SANITARY SEWER LAYOUT
LANKIN ADDITION
May, 1969
R.S. DELAMATER
CONSULTING ENGINEER
WICHITA, KANSAS

We are handing you herewith the tracings for the 48" storm sewer and the sanitary sewer which have been constructed to serve the Lankin Addition.

These tracings have been corrected to indicate the grades and dimensions as built and also to include the connecting lines into the sewers; in the case of the storm sewer we have indicated the location, flowline and grate elevation of the inlets which discharge into the manhole at the eastern end of the line.

48" STORM SEWER LAYOUT
LANKIN ADDITION
May, 1969
R.S. DELAMATER
CONSULTING ENGINEER
WICHITA, KANSAS

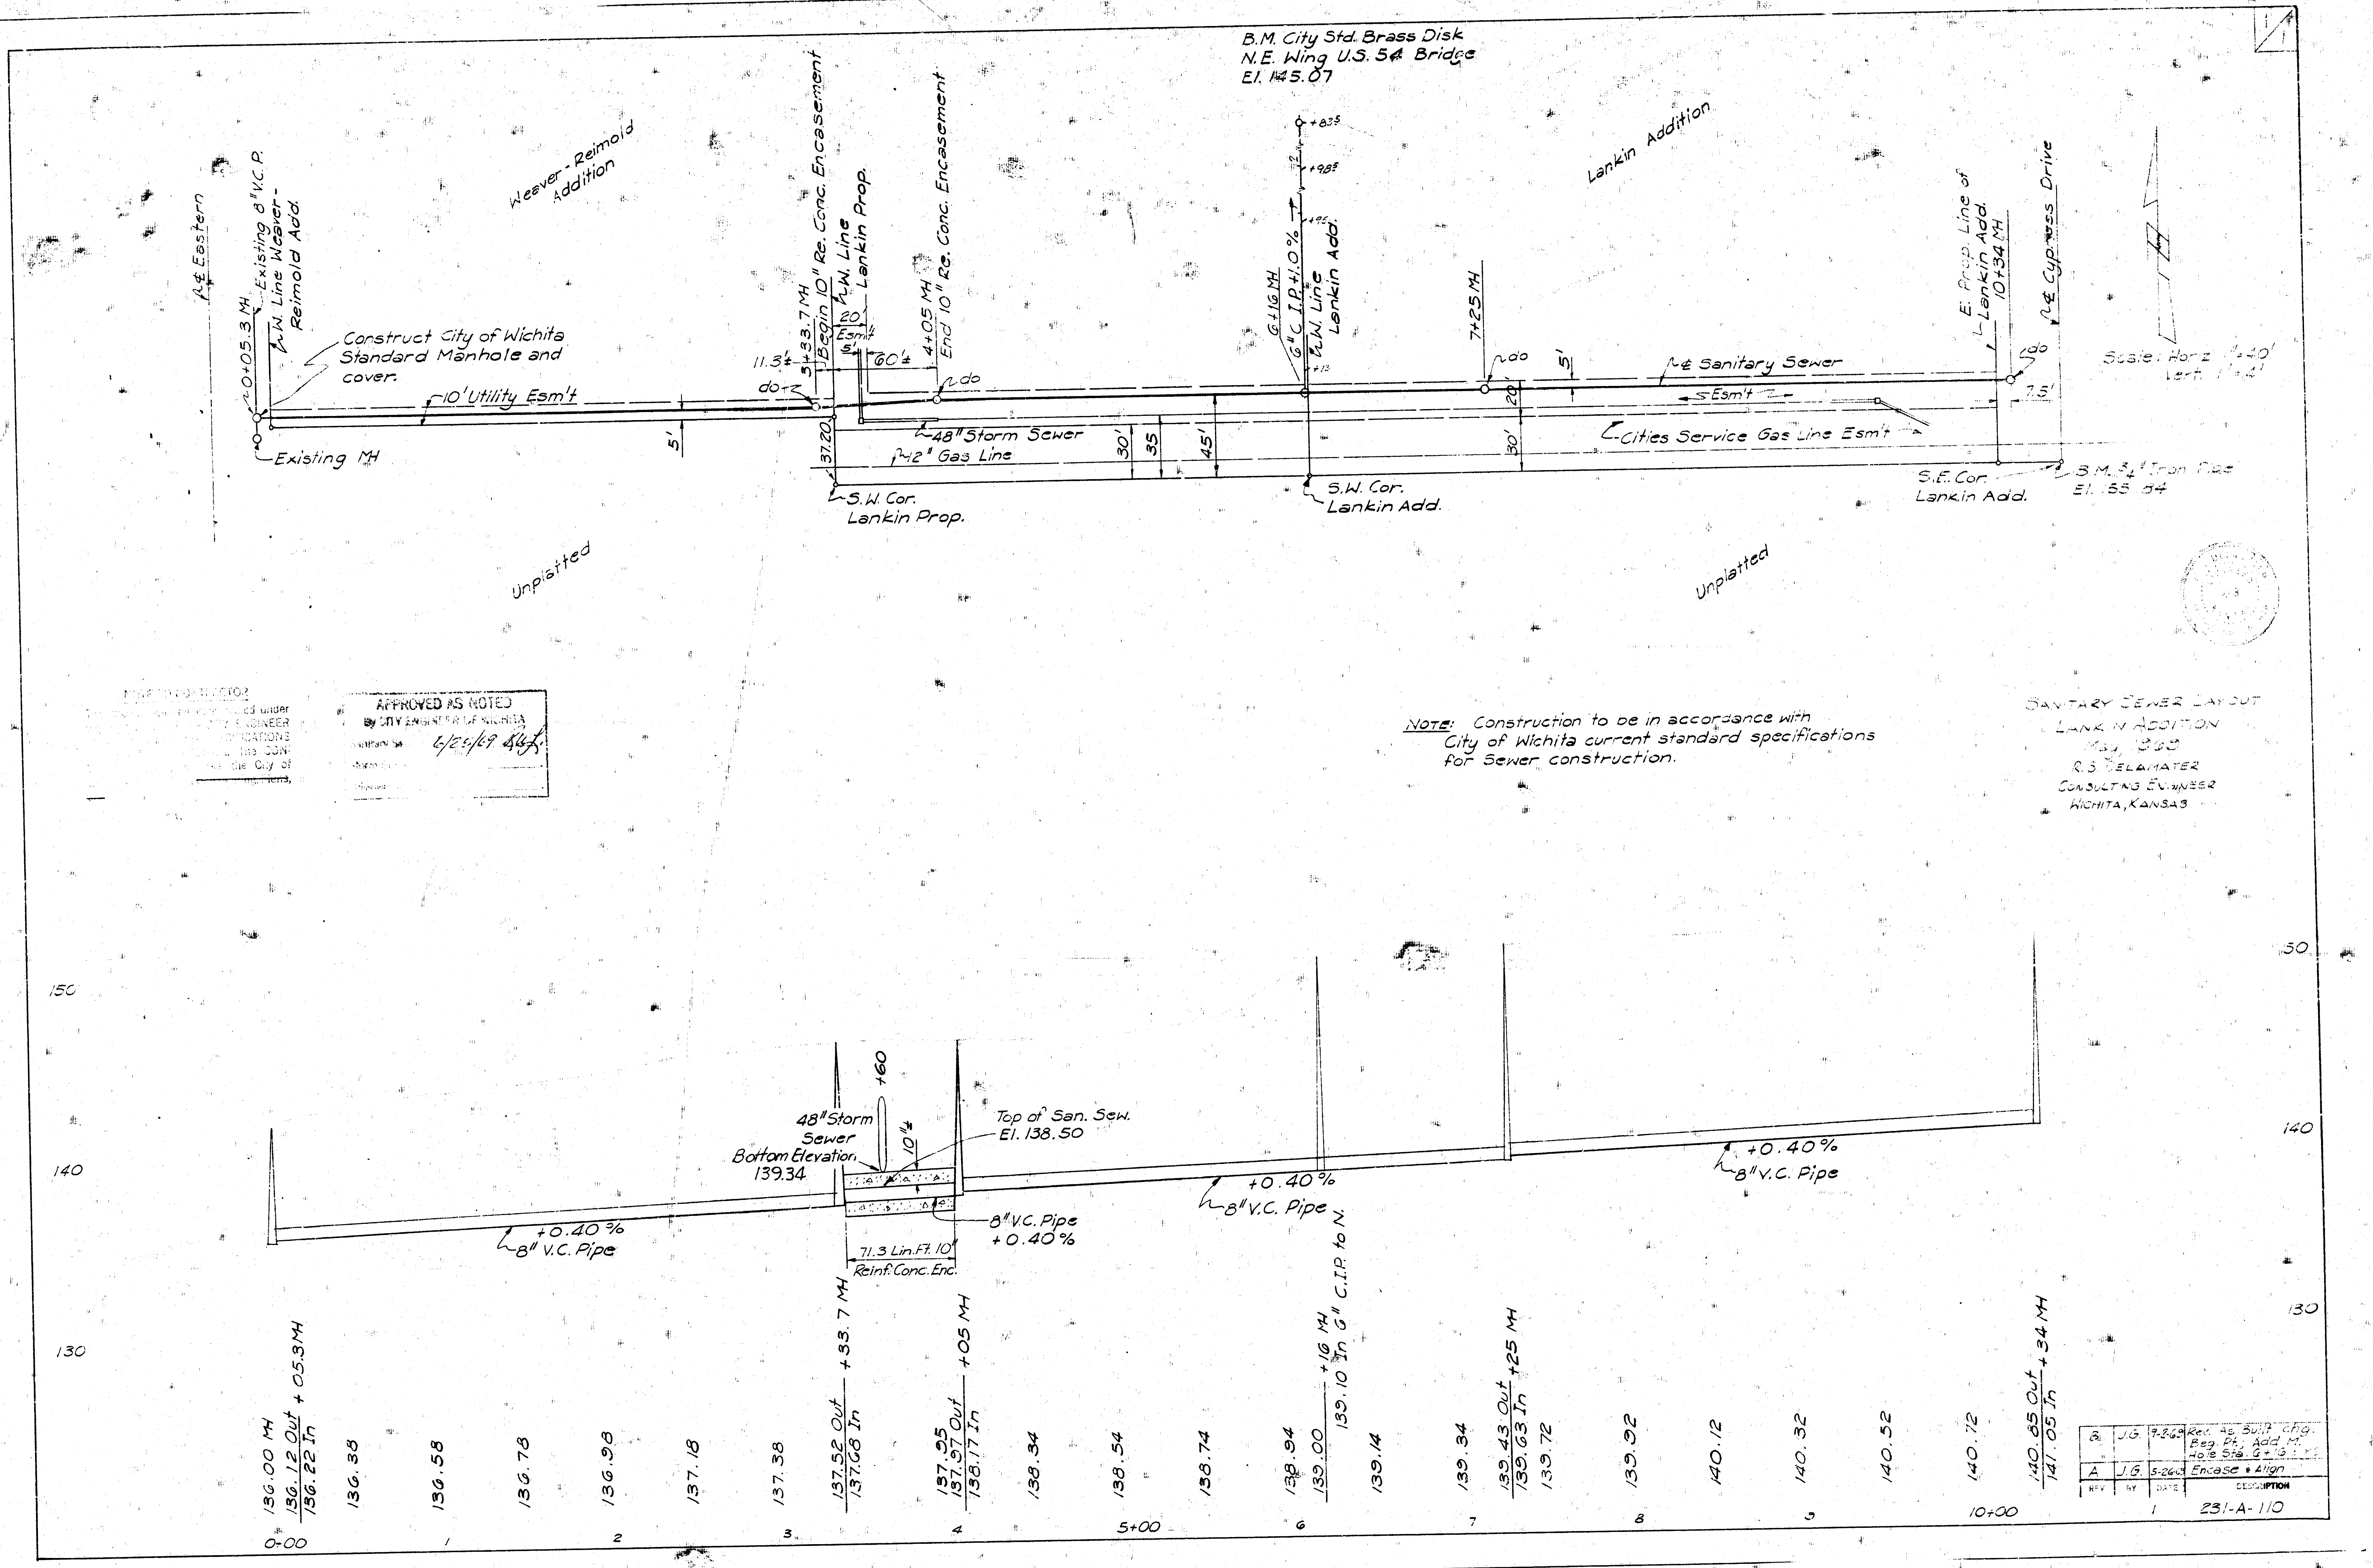
B.	J.G.	7-2-69	Rev. As Built chg. Beg. Pt.; Add M. Hole Sta. 6+16
A	J.G.	5-26-69	Encase & Align
REV	BY	DATE	DESCRIPTION

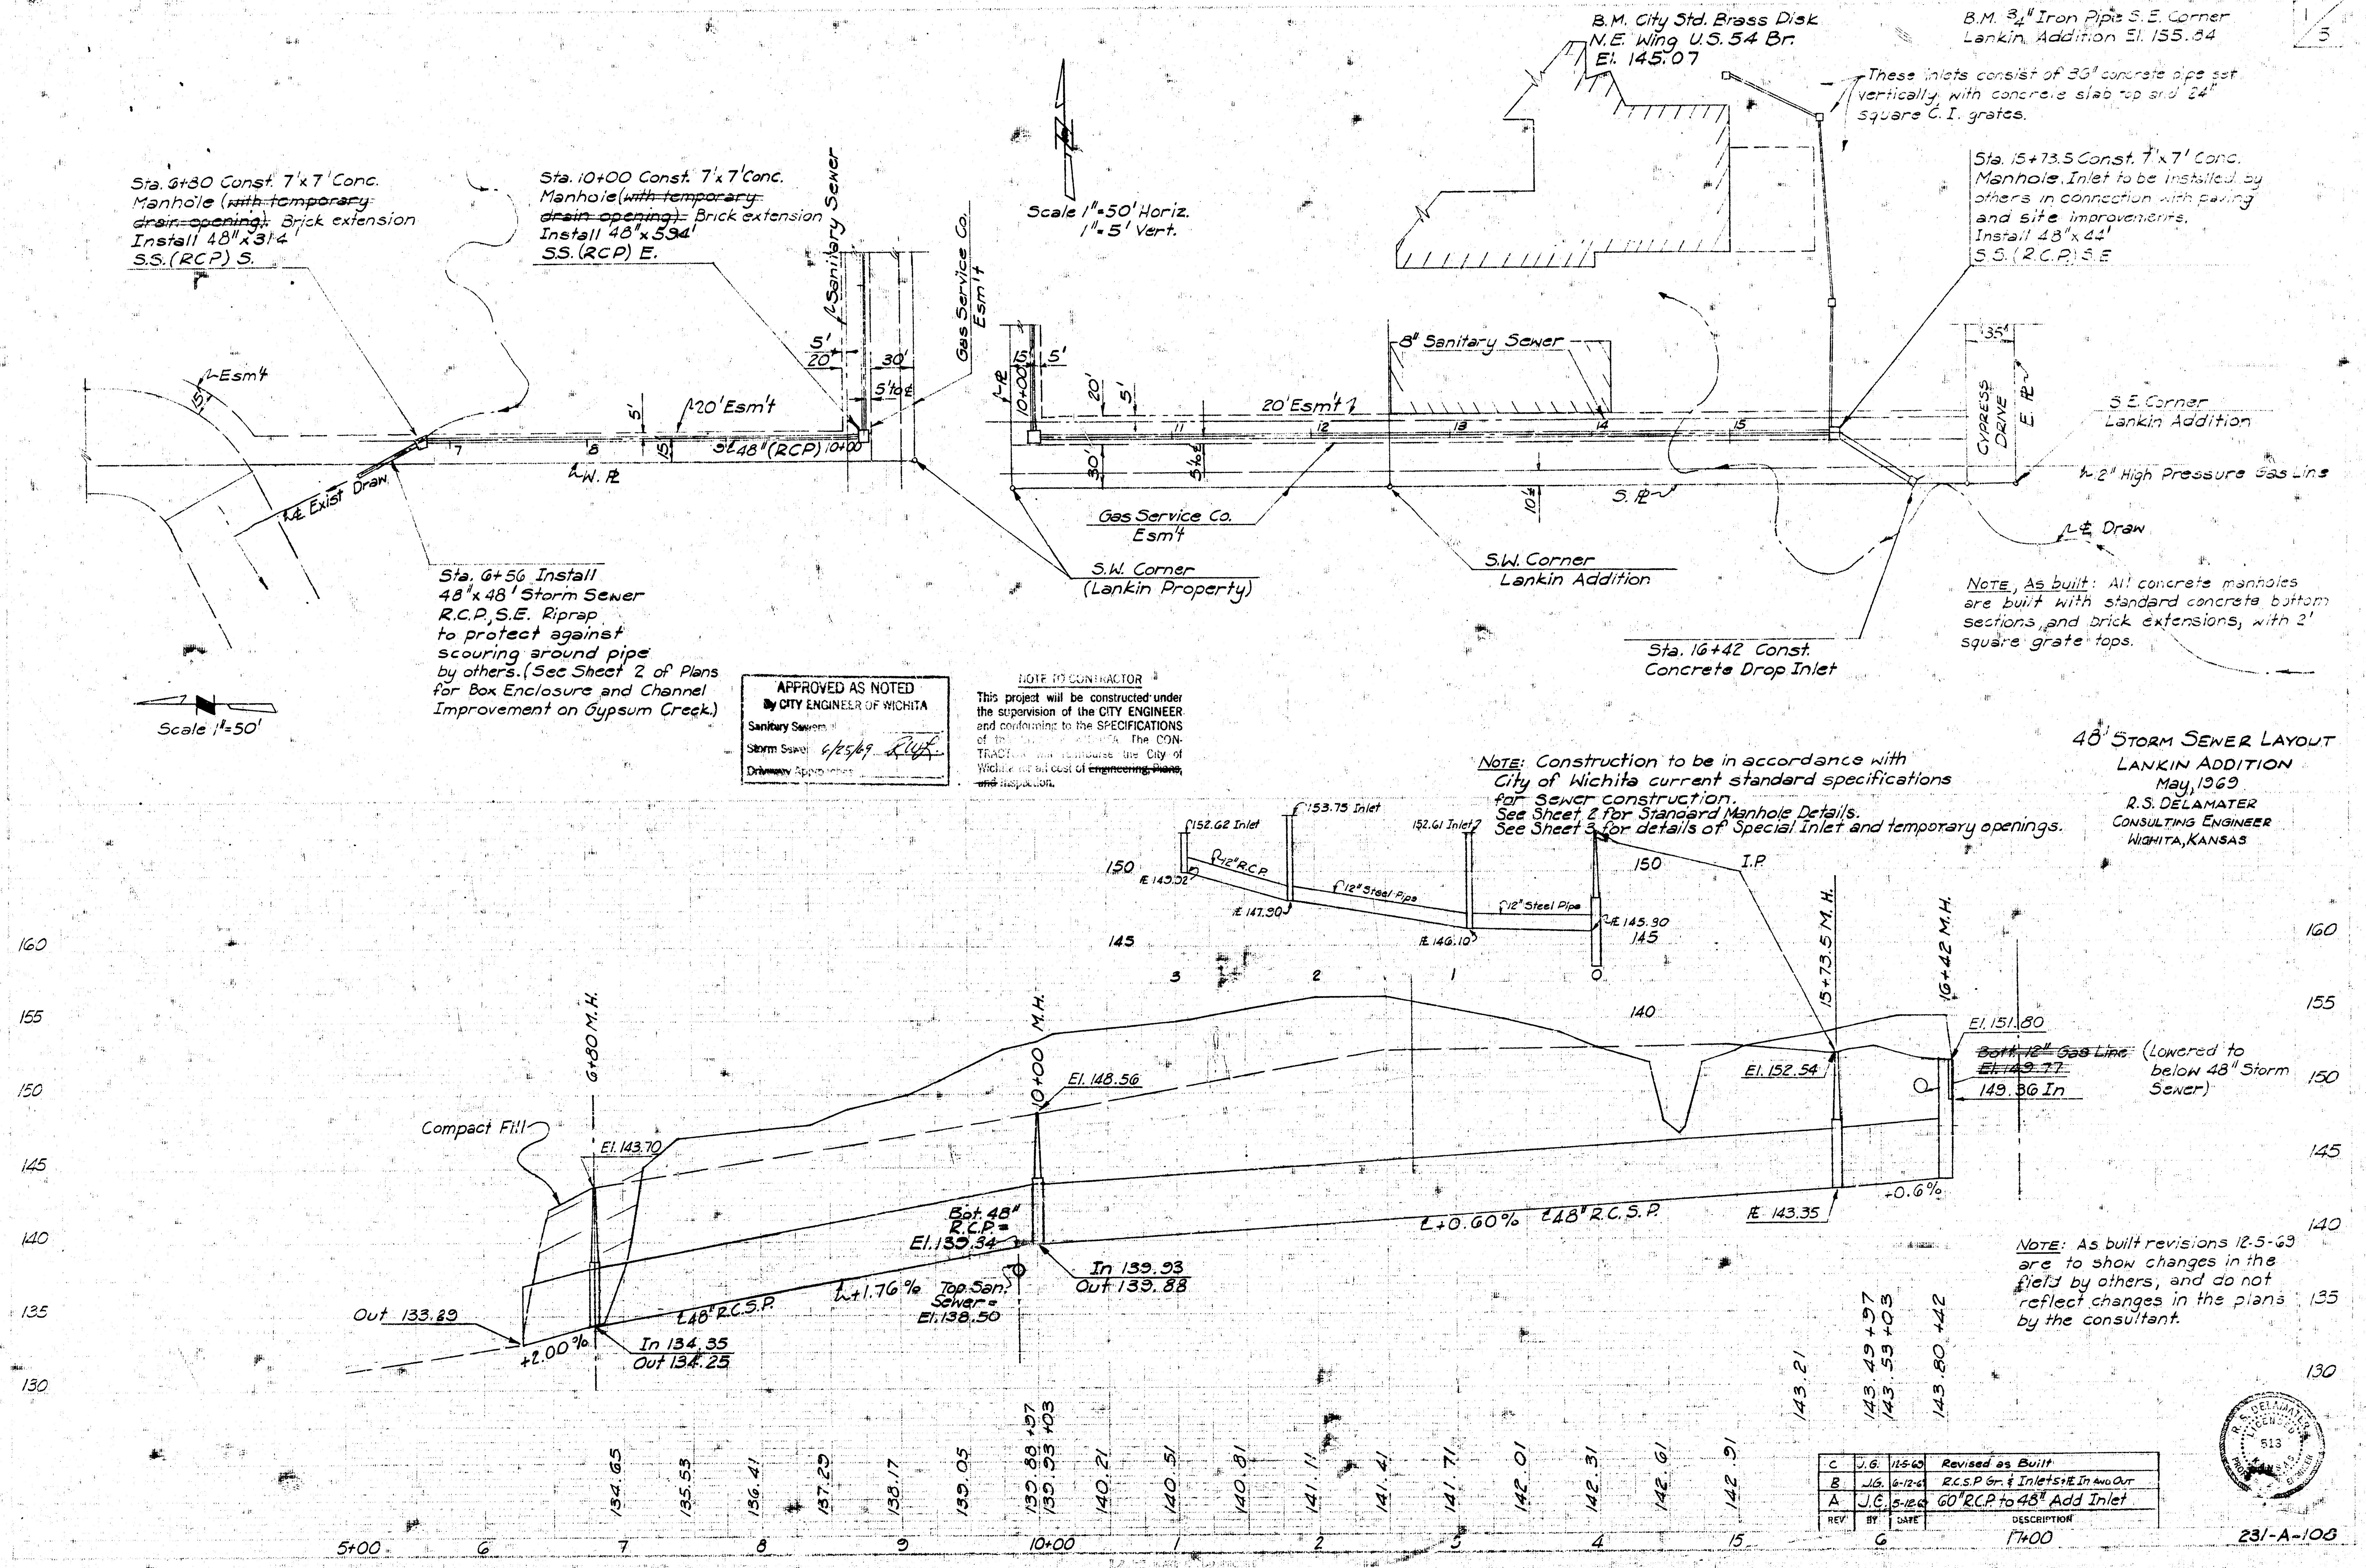
152.62 Inlet
153.73 Inlet
152.61 Inlet
12" R.C.P.
12" Steel Pipe
12" Steel Pipe
E. 143.02
E. 147.90
E. 146.10
E. 145.90
150
145
140
I.P.
3
2
1
0
6+80 M.H.
10+00 M.H.
15+73.5 M.H.
16+42 M.H.
Compact Fill
El. 143.70
El. 148.56
El. 152.54
El. 151.80
~~Bott. 12" Gas Line El. 149.77~~

149.36 In
(Lowered to below 48" Storm Sewer)
Bot. 48" R.C.P. = El. 139.34
In 139.93
Out 139.88
Top San. Sewer = El. 138.50
℄ +1.76%
℄ 48" R.C.S.P.
℄ +0.60% ℄ 48" R.C.S.P.

NOTE, As built: All concrete manholes are built with standard concrete bottom sections, and brick extensions, with 2' square grate tops.

NOTE: As built revisions 12-5-69 are to show changes in the field by others, and do not reflect changes in the plans by the consultant.

REV	BY	DATE	DESCRIPTION
C	J.G.	12-5-69	Revised as Built
B	J.G.	6-12-69	R.C.S.P Gr. & Inlets ℄ In and Out
A	J.C.	5-12-69	60" R.C.P. to 48" Add Inlet
